DEVELOPMENT REVIEW BOARD
SUPPLEMENTAL SUBMITTAL

PROJECT NO. PR-2021-005414

DESCRIPTION: Response to DRB Comments Letter, Revised Site Plan and Utility Plan, Revised Preliminary Plat,

**RE: PR-2021-005414 RESPONSE TO DRB COMMENTS
TRACT F-4-A & F-6-A ATRISCO BUSINESS PARK UNIT 3
441 & 457 COORS BLVD NW**

c1.0

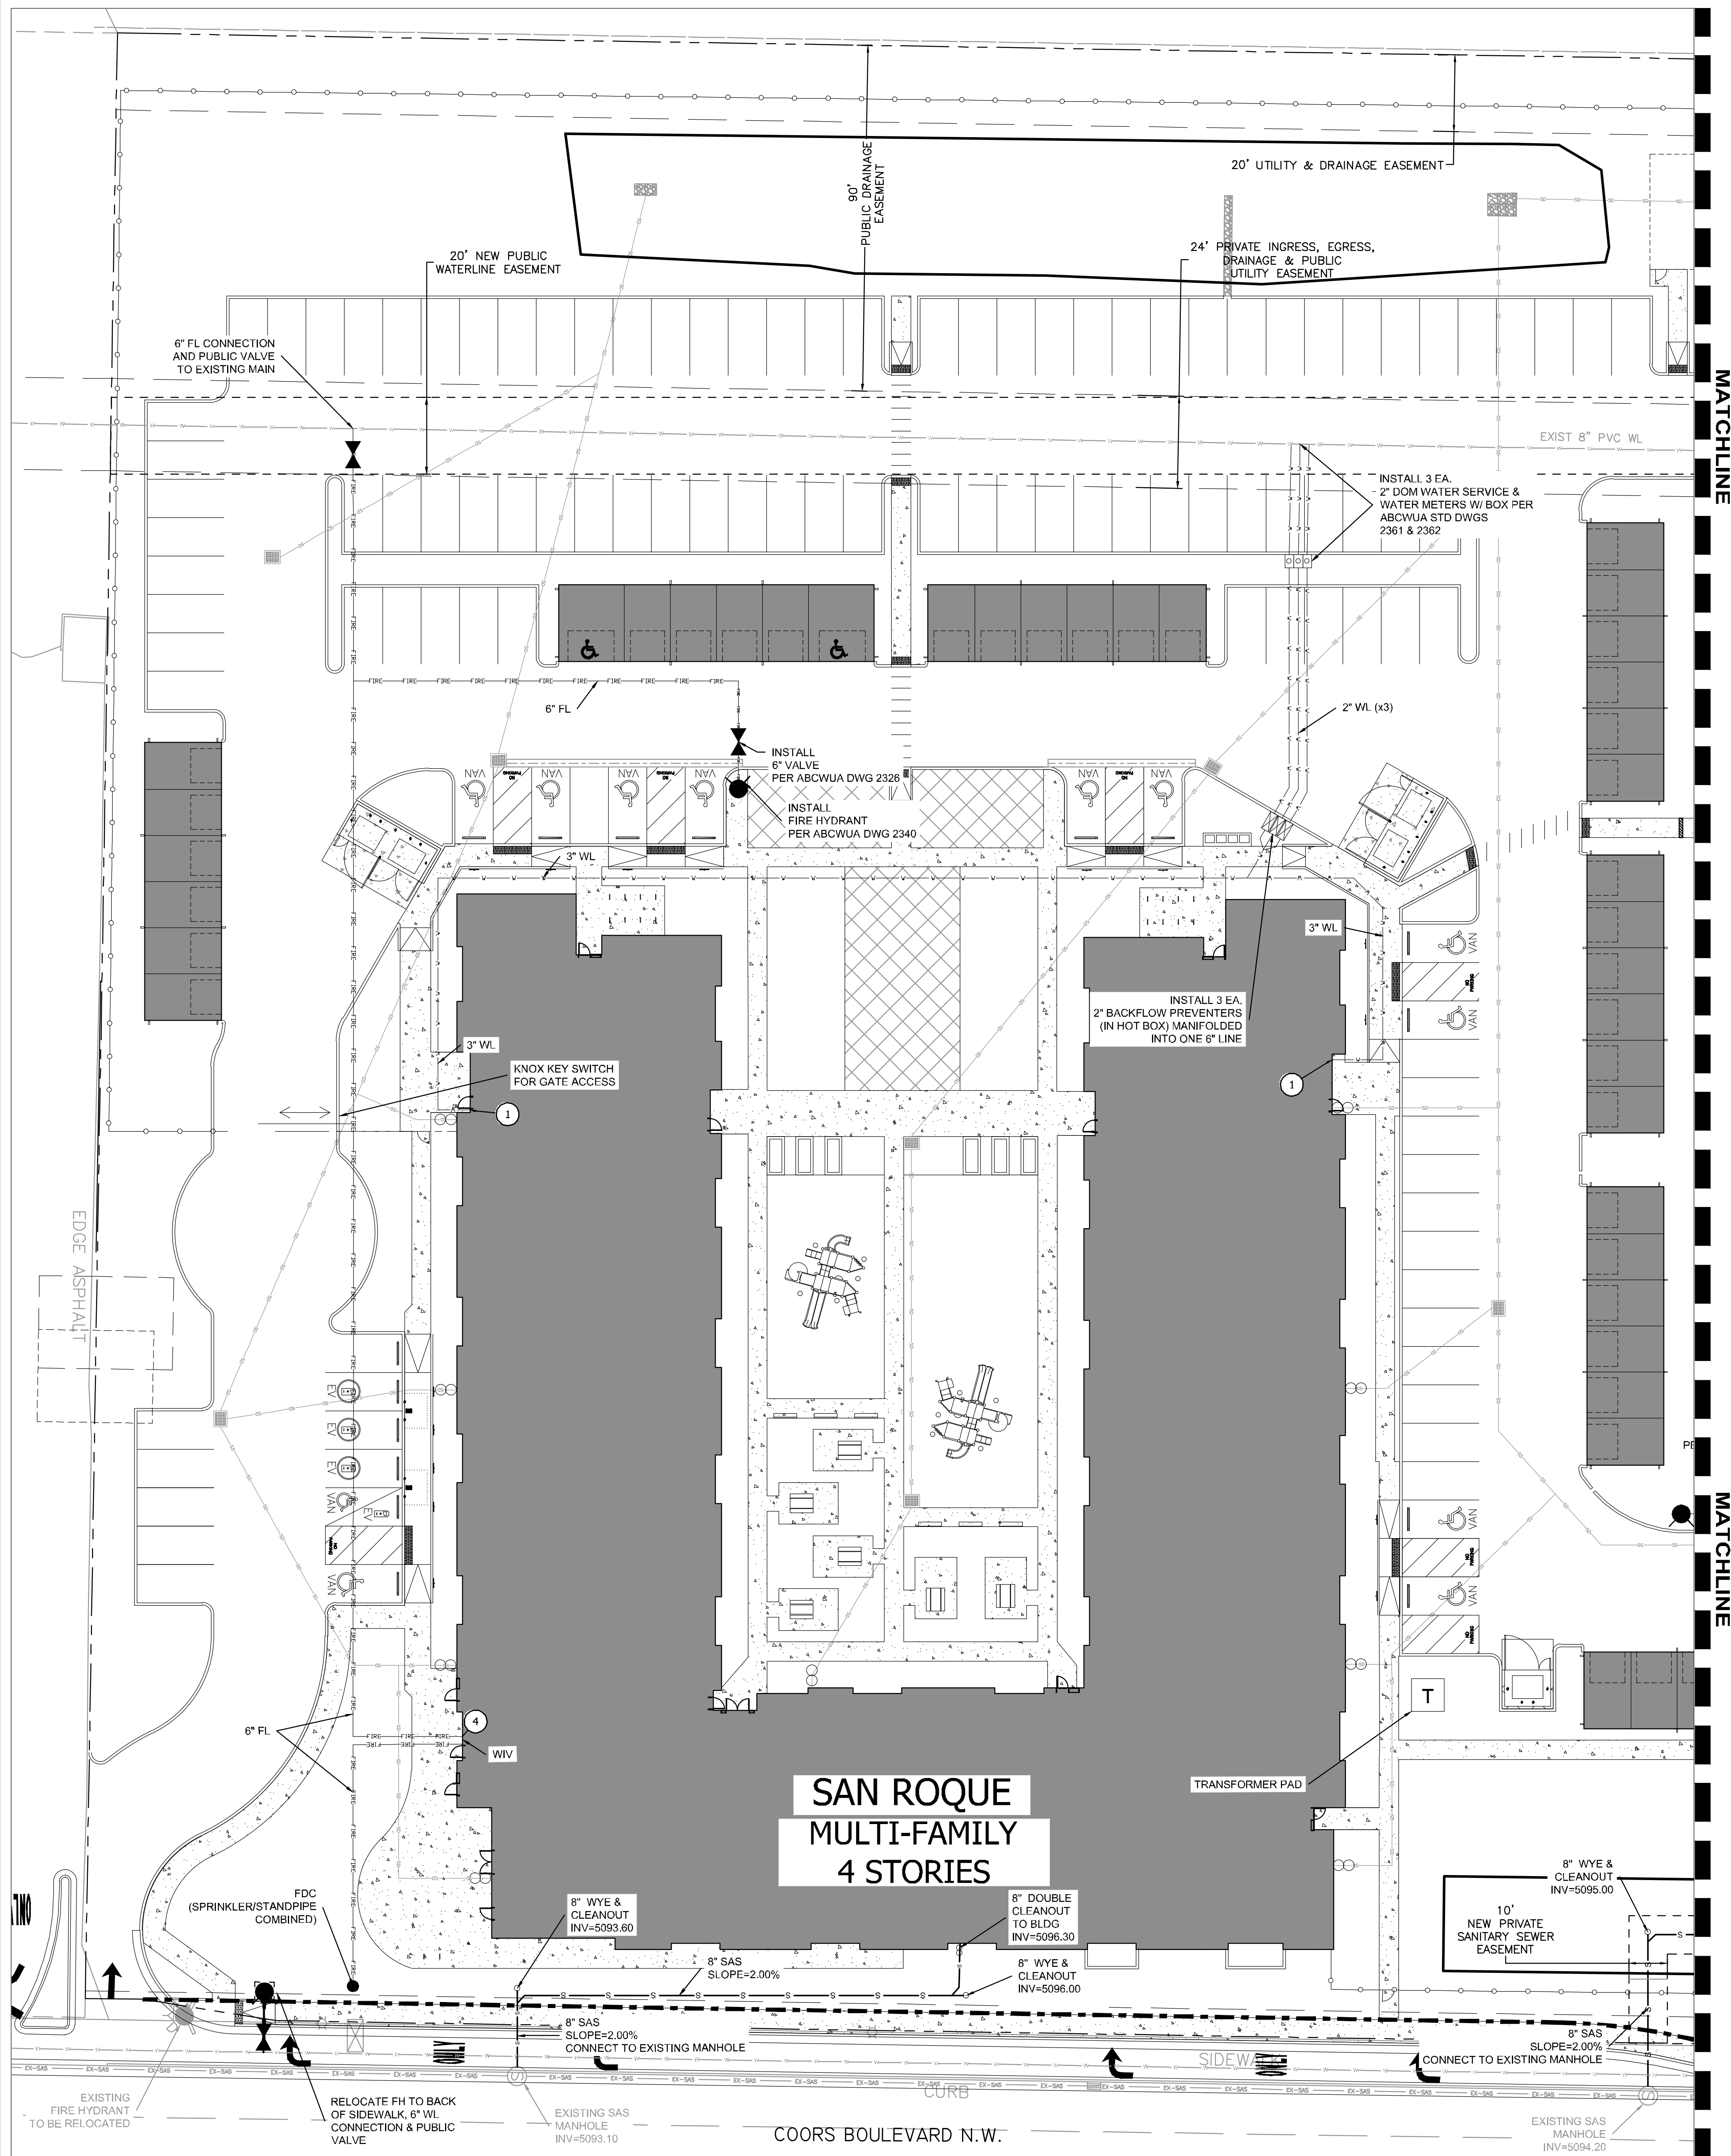
3. Show 6-foot ADA pathway from the offices to the handicapped spaces. (A 5-foot ADA pathway is shown in most cases.)

4. Reference exact curb ramp details on the plan at all locations. On handicapped space detail provided, make a reference to the adjacent curb ramp detail for clarity.

5. Although a turnaround is included from the north access road, a turnaround is not included in front of the gate off of Coors Boulevard. (A hammerhead could be provided for this purpose.)

8. Dimension bike rack areas to insure a 2' x 6' space is provided for each bicycle space. (A detail can be added to show this graphic in addition to adding the notes.)

RESPONSE: For San Roque, the office entrance is at the SE corner of the building. The pathway from these offices to the handicapped spaces is also the same ADA pathway to the public ROW (shaded as red on the site plan). This pathway is 7' wide from the offices to the handicapped spaces and is called out as such.

For La Serena the office entrance is at the NE corner of the 'knuckle' of the building. The pathway from this entrance to the handicapped spaces has a width of 6' minimum and is 7' at the ADA ramp and landing in front of the handicapped spaces. These widths are now shown on the site plan.

RESPONSE: Most ramps are parallel curb ramps and are now called out as such with Keyed Note 15. The only other ramp is a flared curb ramp at the main entrance to La Serena and is called out as such with Keyed Note 16. Both keyed notes refer to detail Sht C7.0, which has both ramp details and is included in this resubmittal.

RESPONSE: A turnaround has been provided by modifying the curbs in front of the gate to have a turnaround diameter of 52' to allow passenger vehicles to turn around. This has been coordinated with Ms. Wolfenbarger who has deemed this turnaround adequate. The vehicle turnaround exhibit is also included in this resubmittal.

RESPONSE: The site plan now show a 4' x 6' dashed rectangle around each bike rack that is called out by Keyed Note 5. The Keyed Note refers to the Detail Sht. 7.0, which has been updated to show the bike rack in plan view with dimensions for a 2' x 6' space on each side of each rack. The notes of the bike rack detail also give additional notes and to refer to DPM and IDO requirements. 1' clear zone is also called out to be around the bike spaces and this is confirmed on the site plan sheet.

Master
Utility Plan
San Roque
c3.0

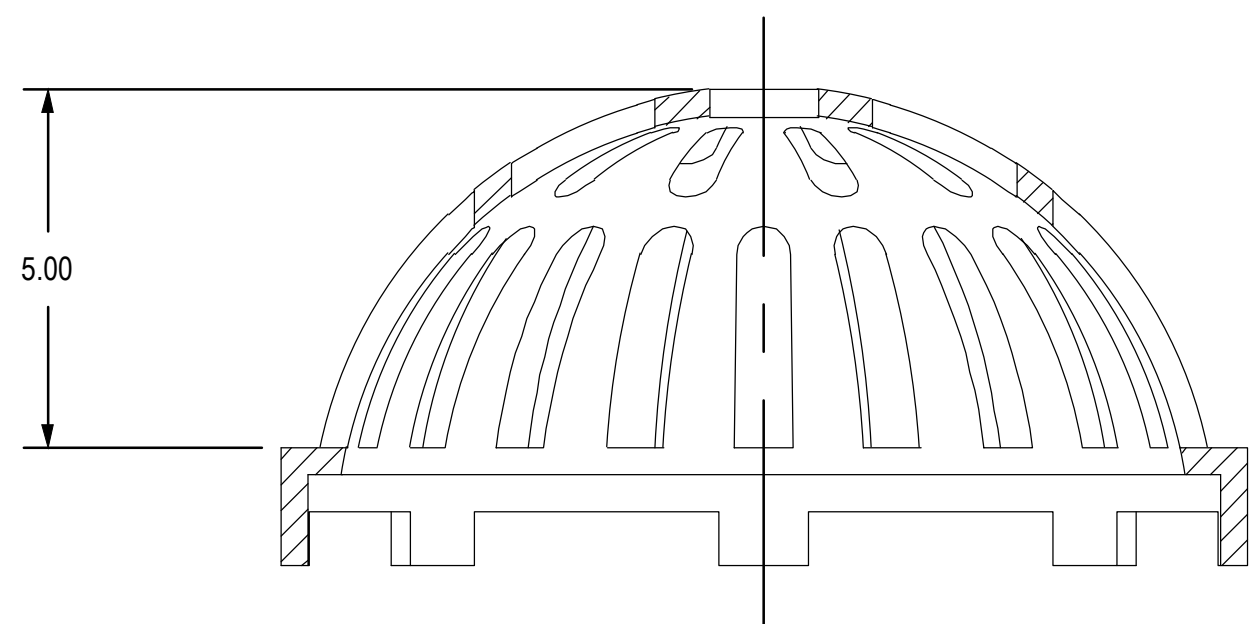
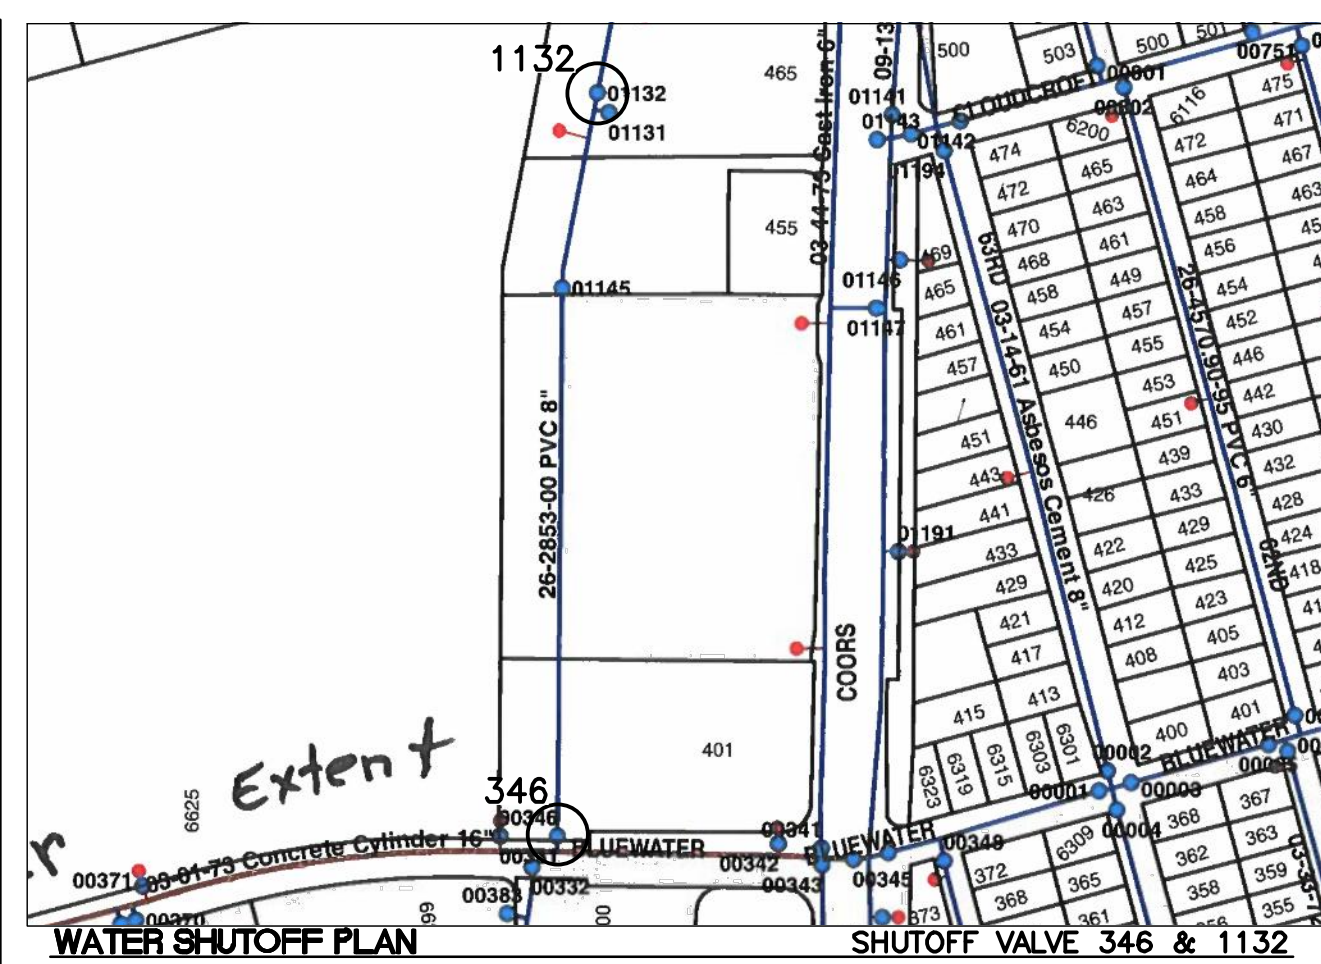
1. Relocate the leader of the fireline connection on sheet C3.0 that is not pointing at any connection.
RESPONSE: Sheet C3.0 has been updated for removing the fireline connection callout.
2. Dedicate easement 14 as public waterline easement where not being relocated to the new easement.
RESPONSE: The plat has been revised so that the 20' public waterline easement being granted with this plat carries all the way to the south property line of Tract F-4-A-1.

landscape
plan
L1.20

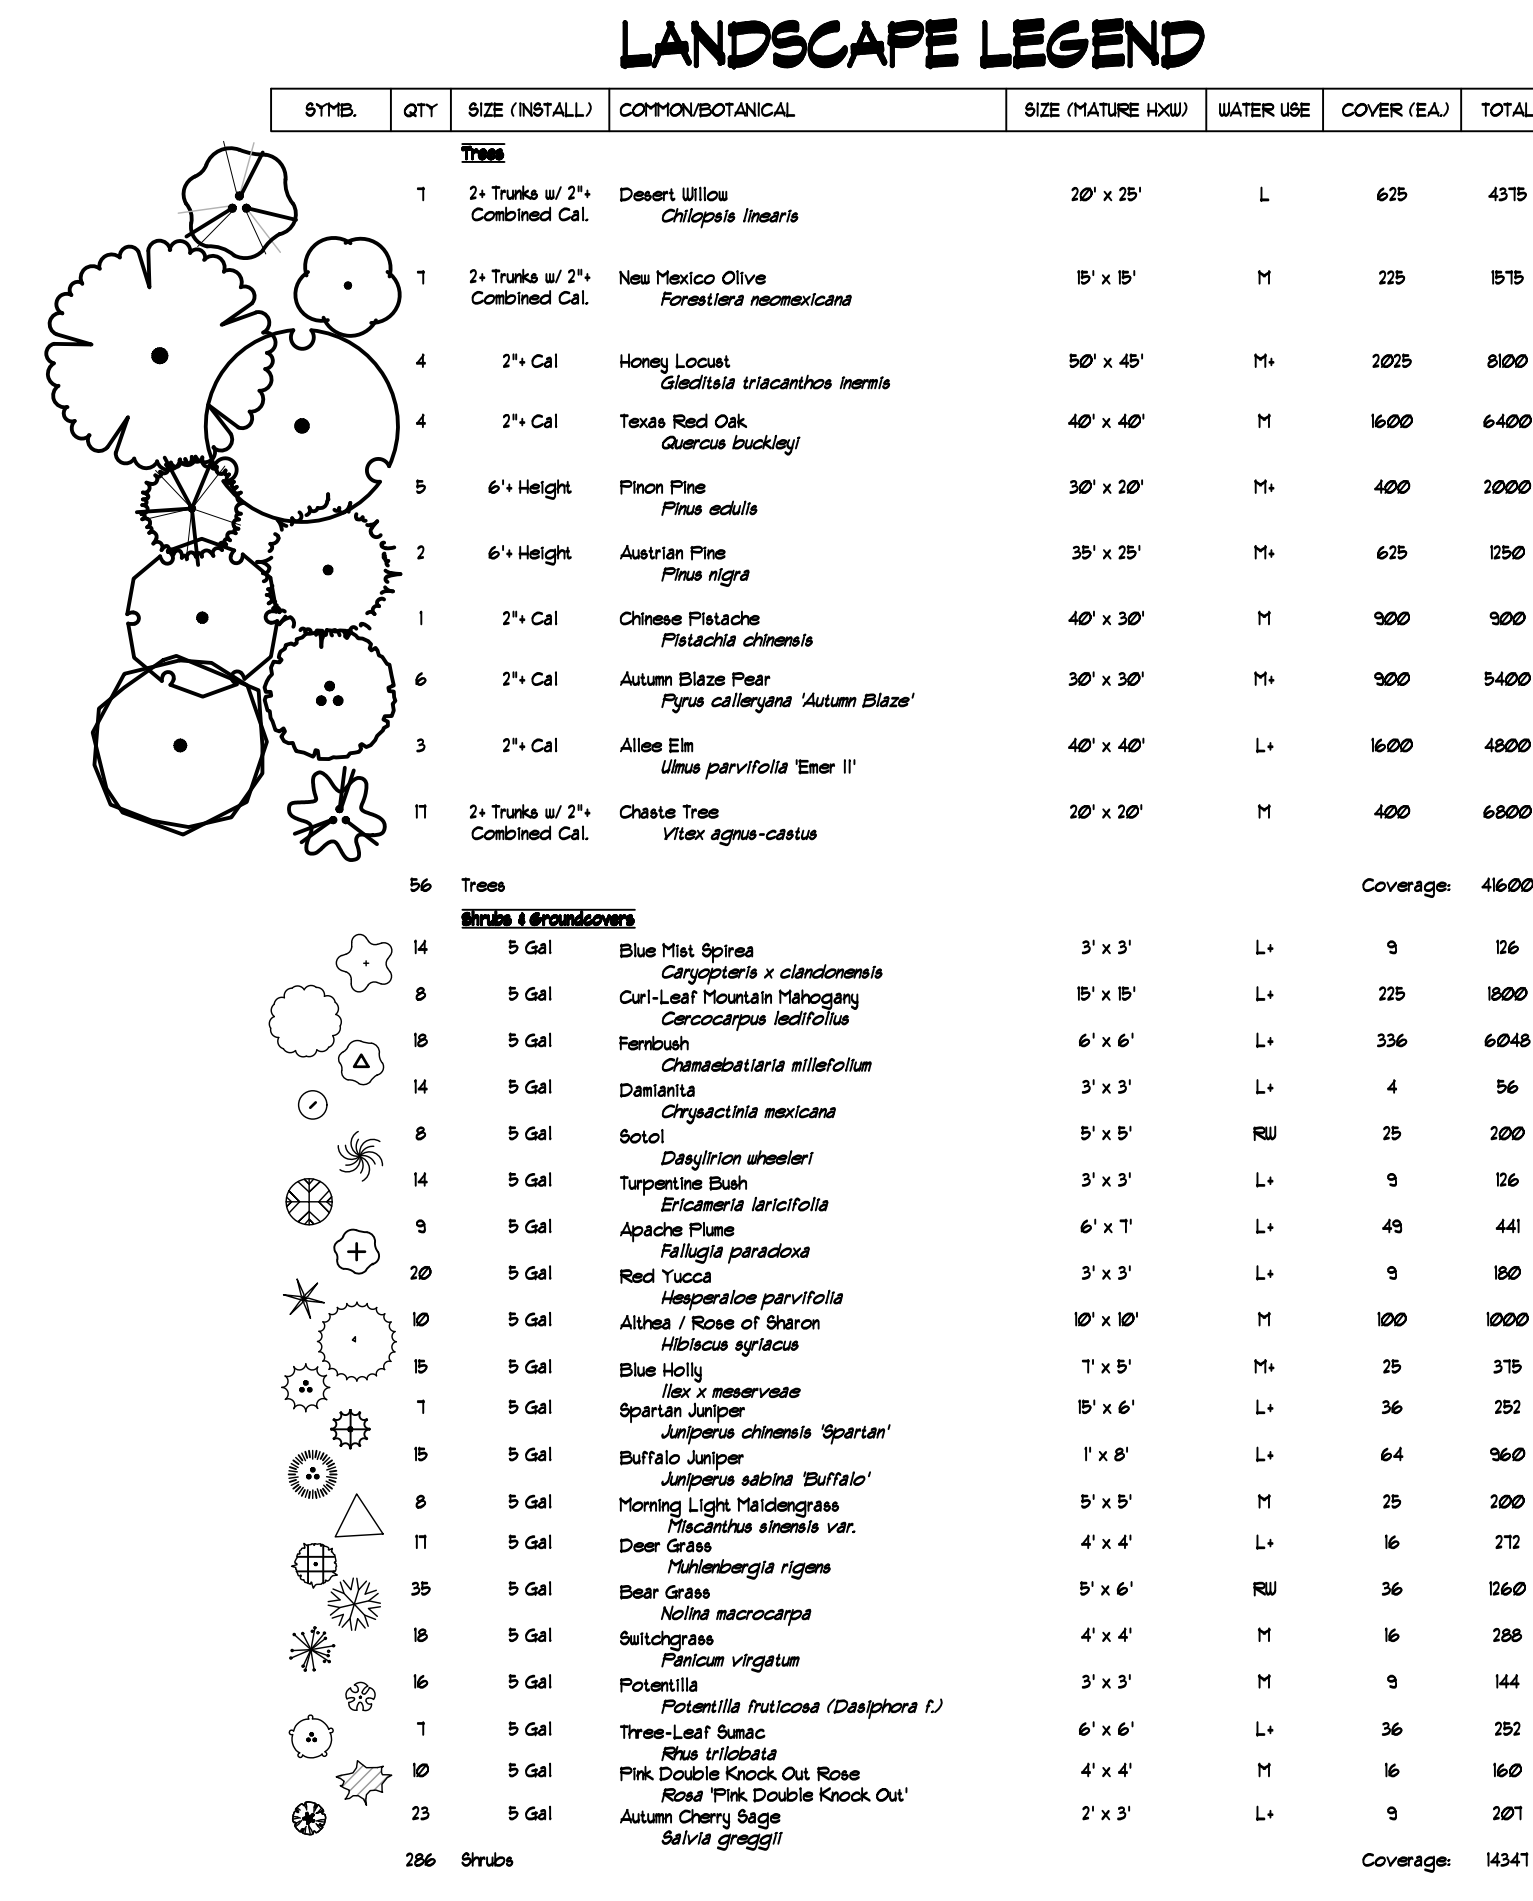
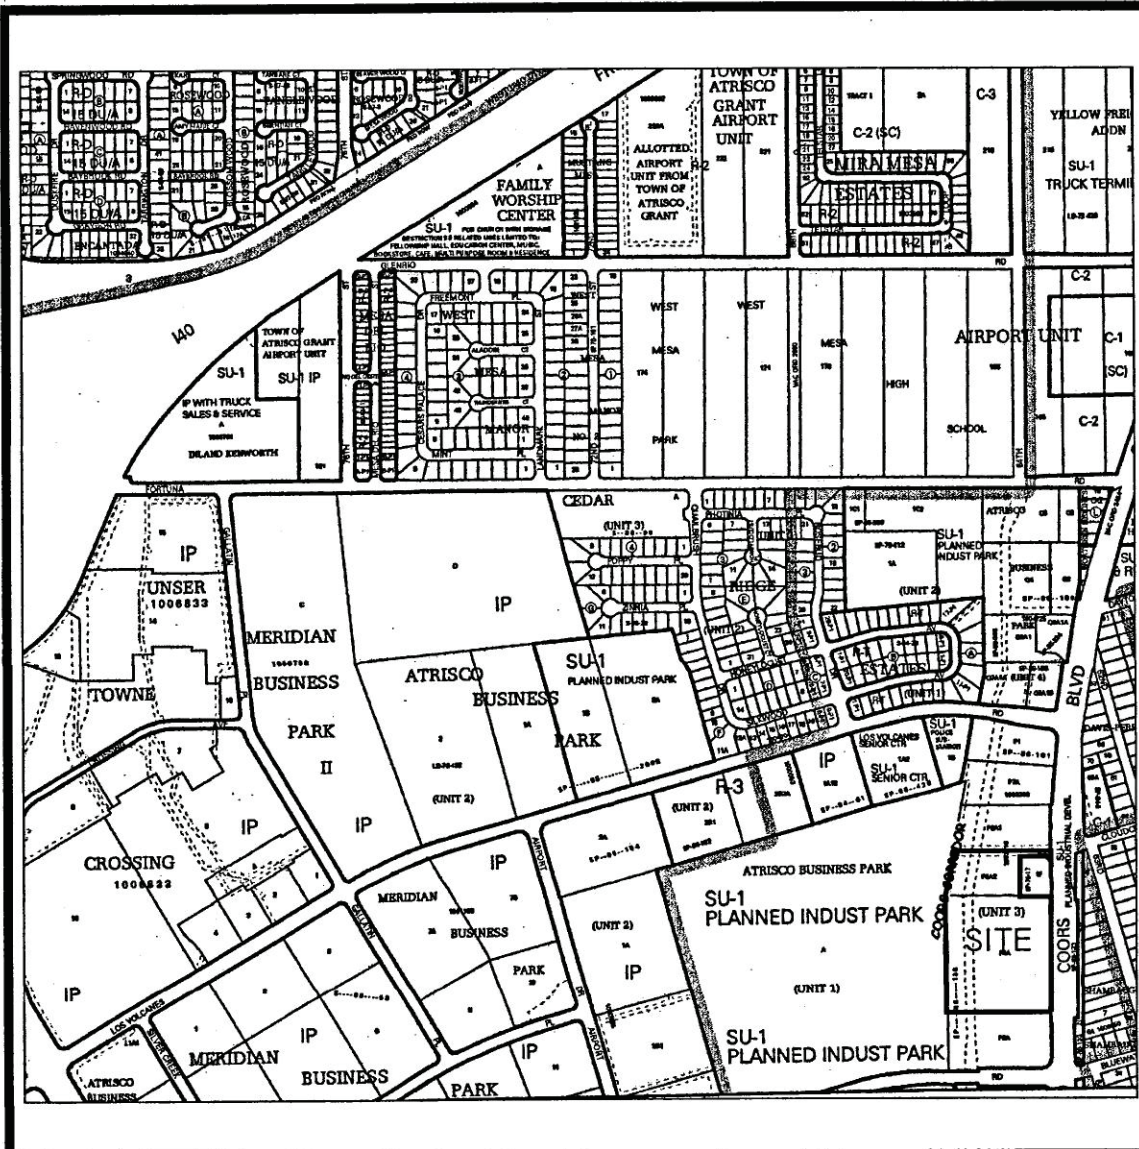
1. Site Plan shows street trees as previously commented, please label street on Landscape Plan.

4. Please add note regarding organic mulch around trees per IDO 5-6(C)(5)(e): Organic Mulch is required as ground cover under trees within a 5-foot radius around the tree trunk, but not directly against the trunk. In these areas, weed barrier fabric is prohibited.

RESPONSE: Coors Boulevard is now labeled on the Landscape Plan.

RESPONSE: A planting note has been added to the landscape plan for this required language.
